**City of Richmond
Department of Planning
& Development Review**

PROPOSAL: Final review of modifications to approved final plans for improvements to the 17th St Farmer's Market

17th St. Market – Public Square – FINAL Design Submission (Resubmittal):

17th Street Market UDC Resubmittal

Changes Since UDC Final Review

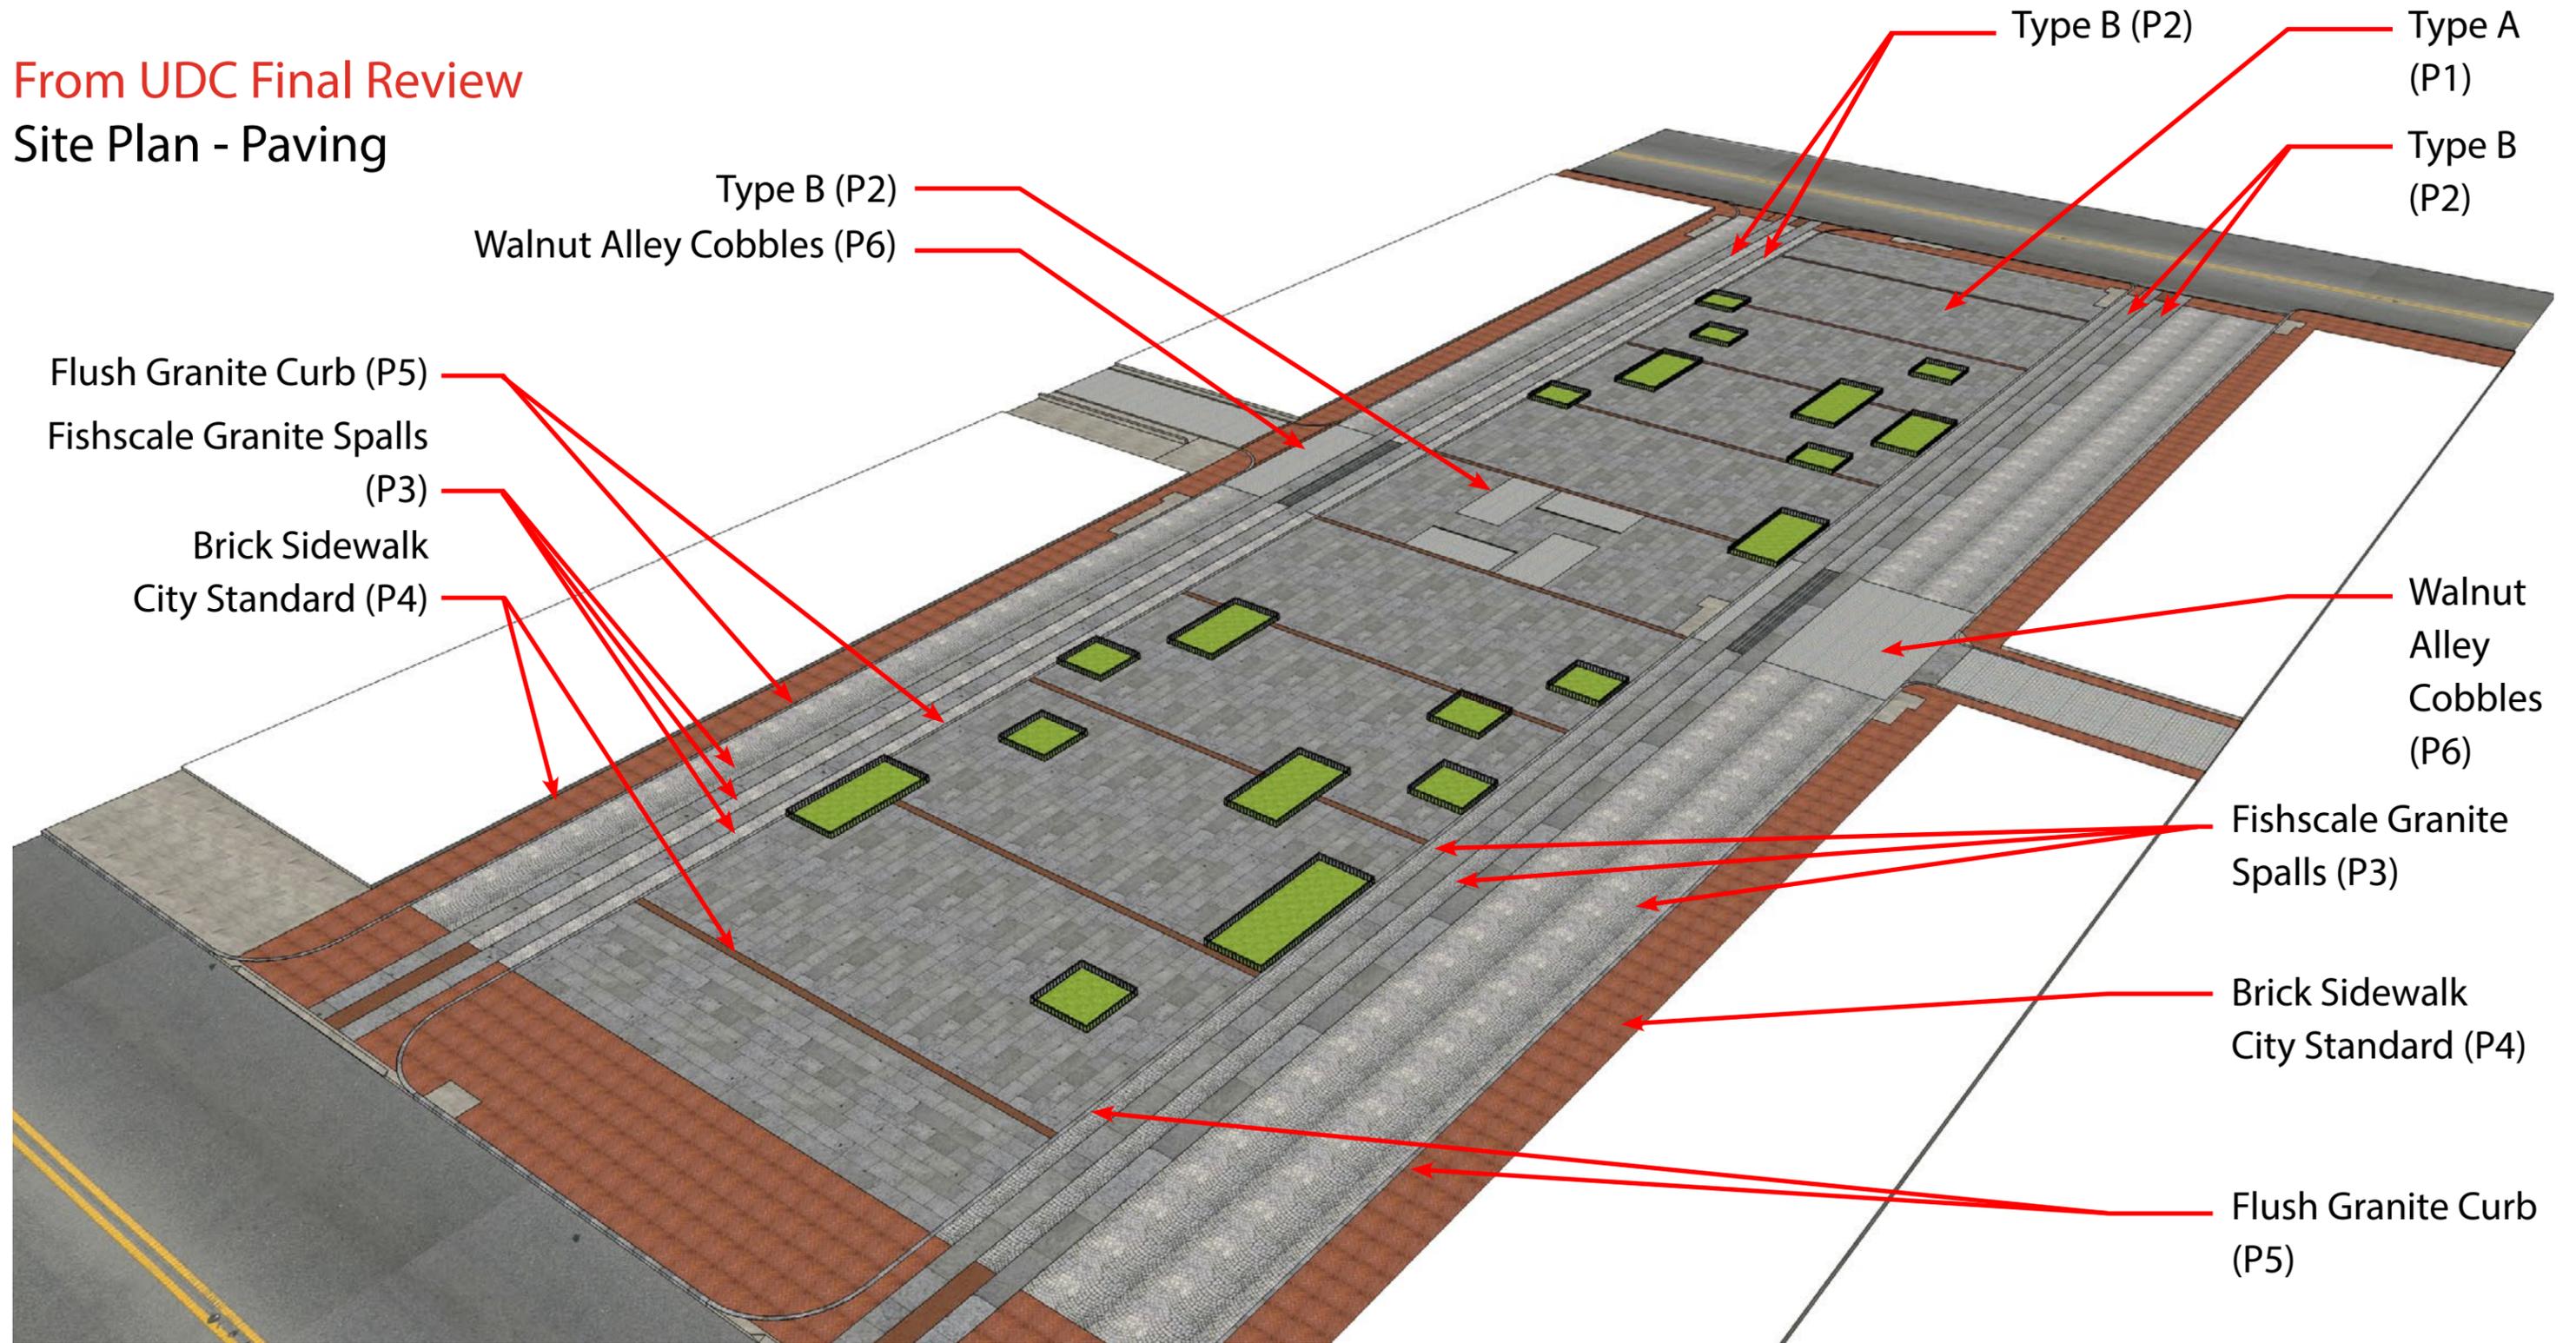
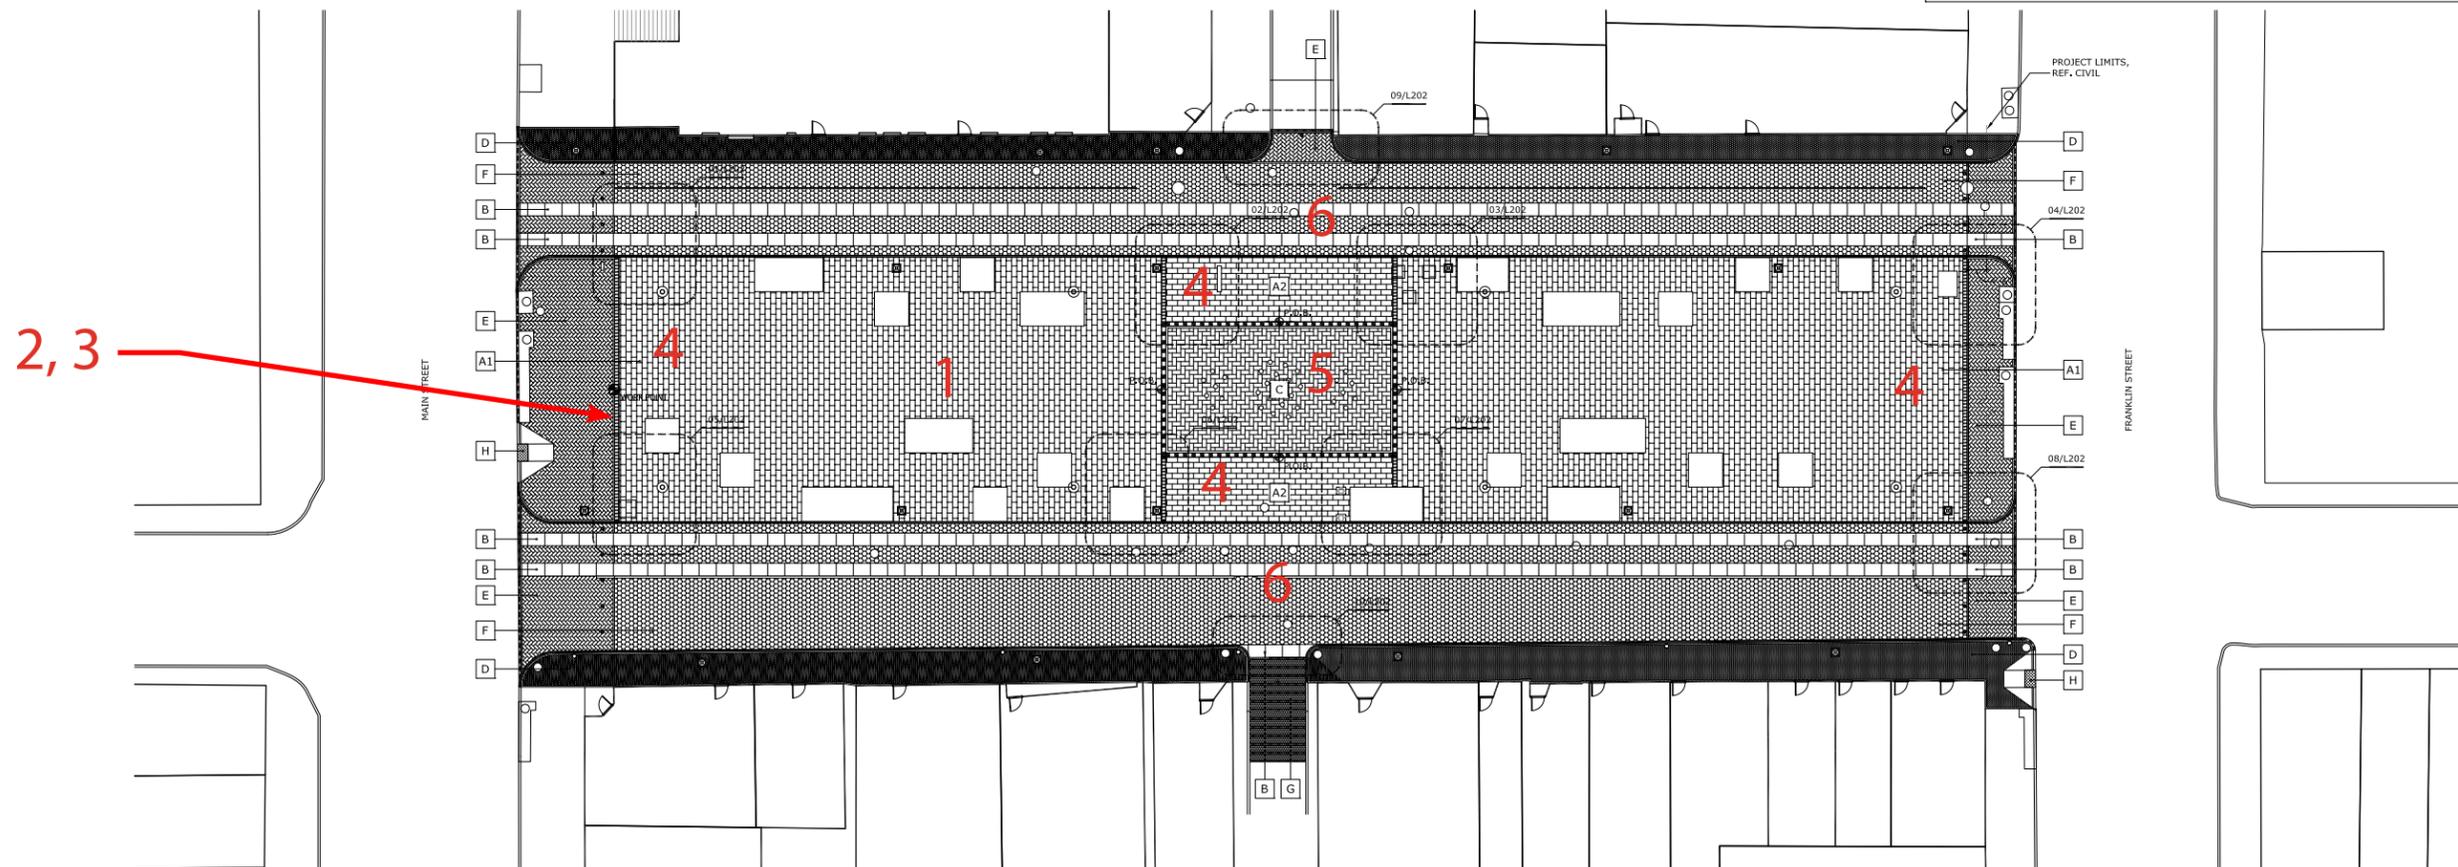
1. Type A granite paver replaced with pressed paver (see image next page).
2. Cross banding: city standard brick replaced with flush granite paving.
3. Fewer cross bands.
4. Paver orientation at fountain, at Main & Franklin Streets.
5. Fountain layout to accommodate children fountains and central backdrop fountain functions
6. Type B cart path paving added. Type G Walnut Alley cobble removed from 17th Streets, replaced with Type F fishscale cobbles.

Changes Since UDC Final Review

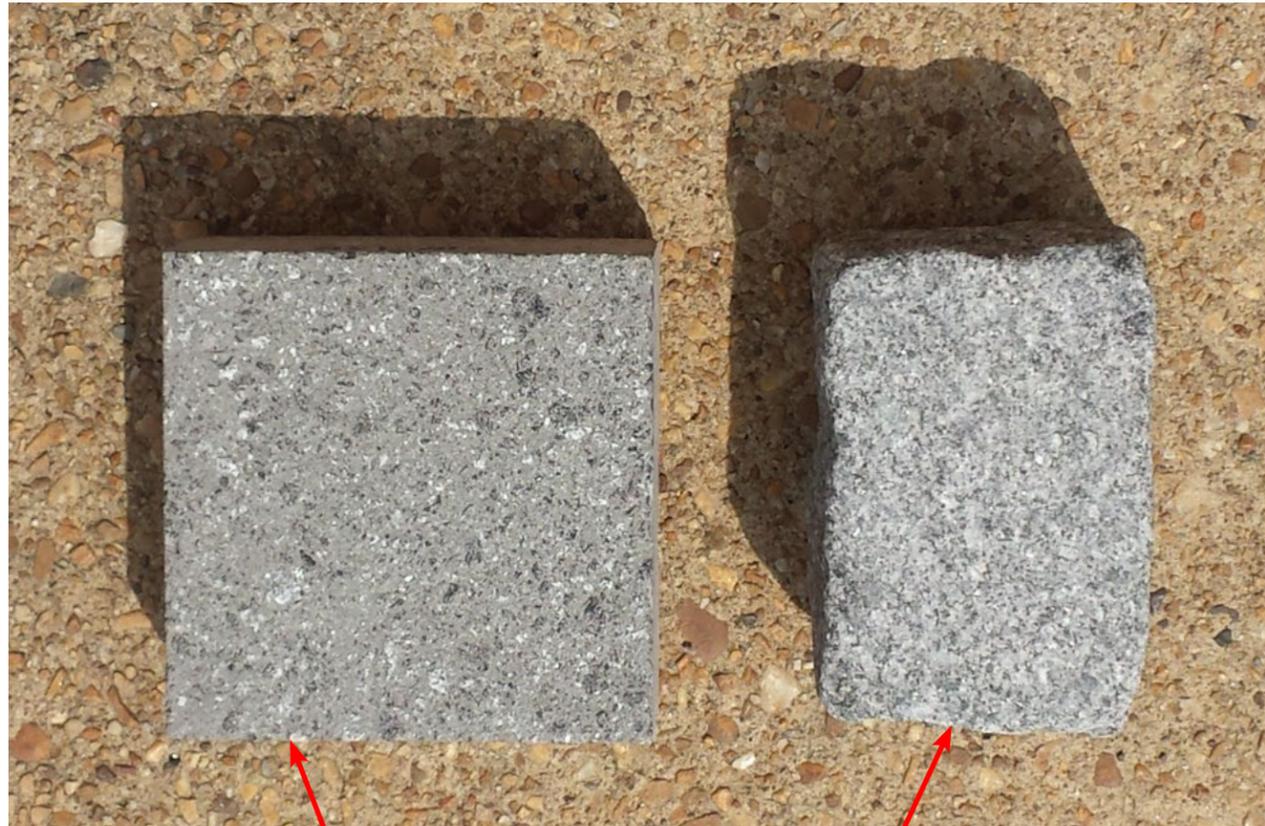
1. Type A granite paver replaced with pressed paver.

Changes Since UDC Final Review

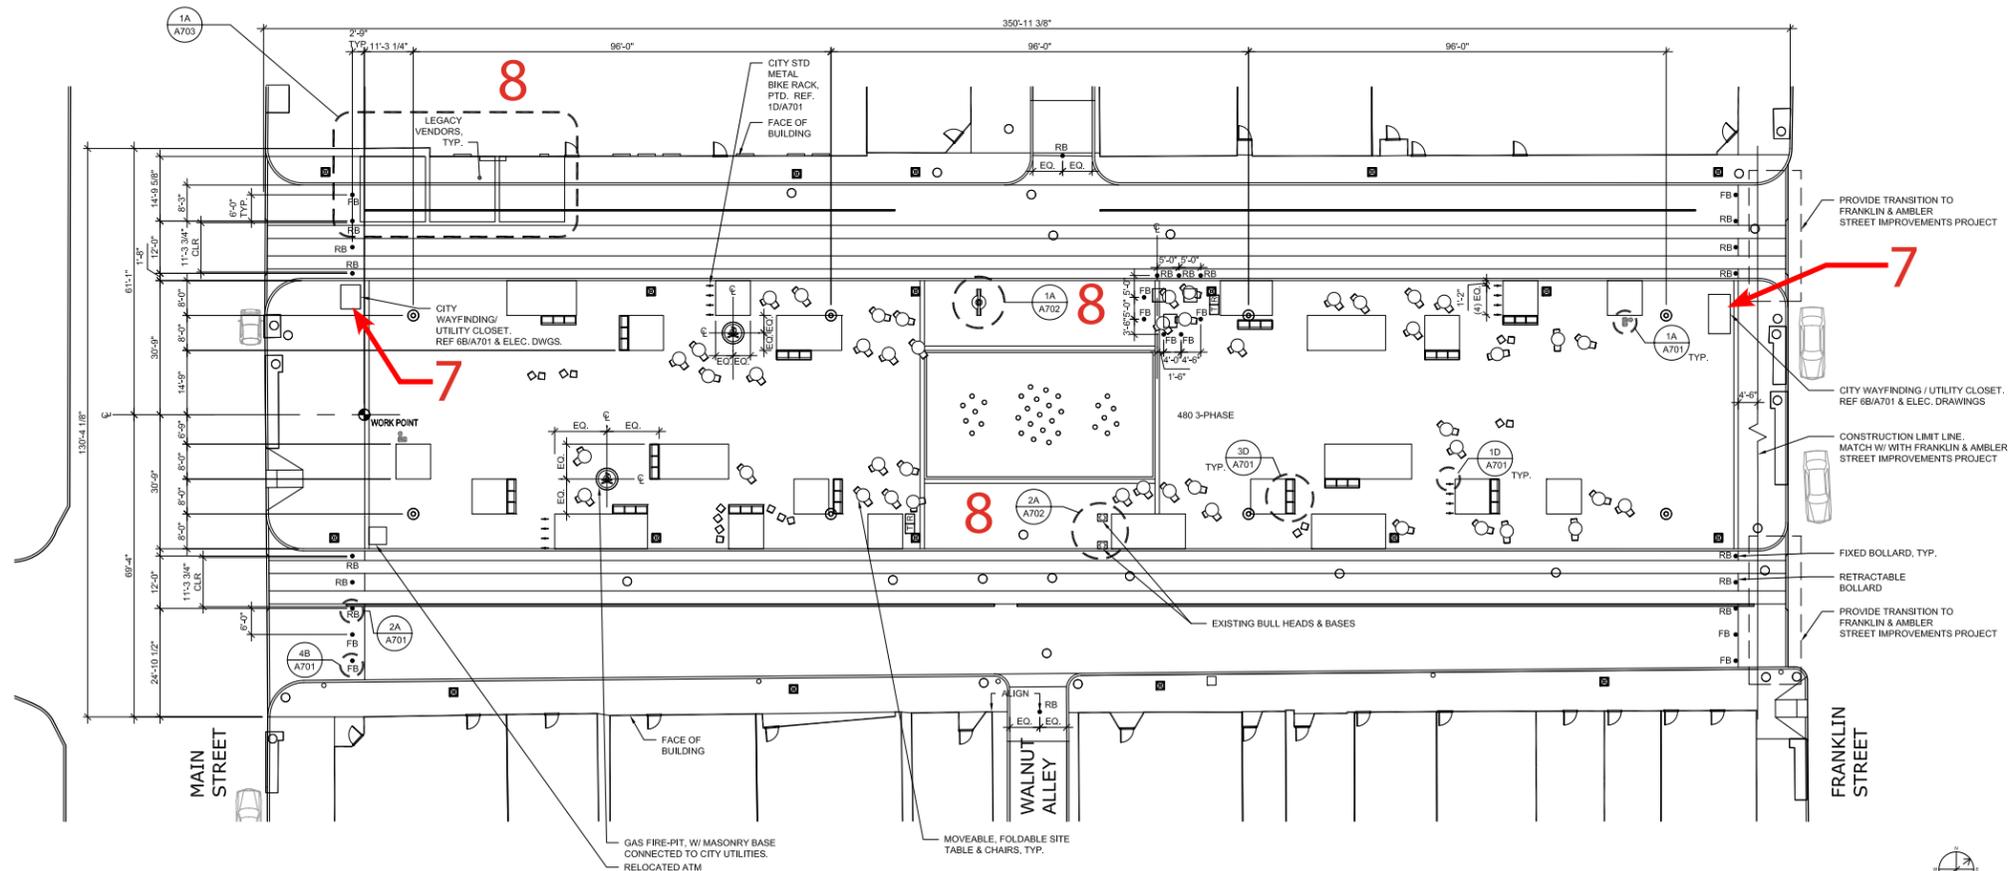
- 7. City wayfinding pylons grew to accommodate electrical panel boards (see following page).
- 8. Legacy vendor sheds, historic artifacts, historic bell, farmer's market sign structures developed (see following pages).

City wayfinding pylon at Franklin Street

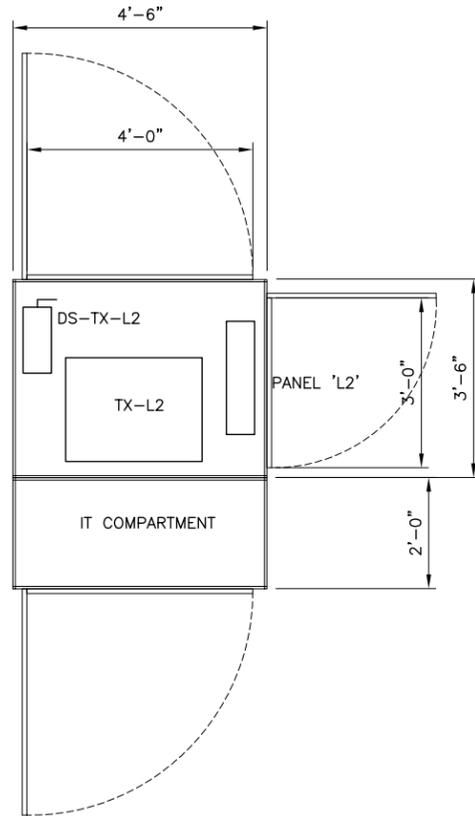
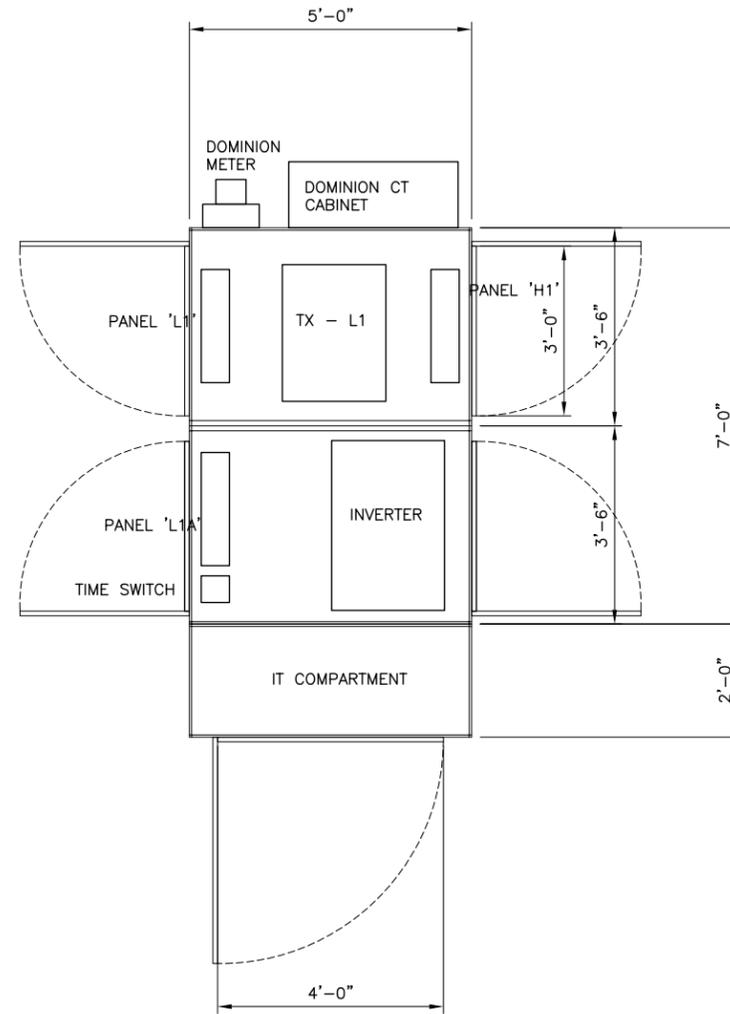
- 7. City wayfinding pylons grew to accommodate electrical panel boards.
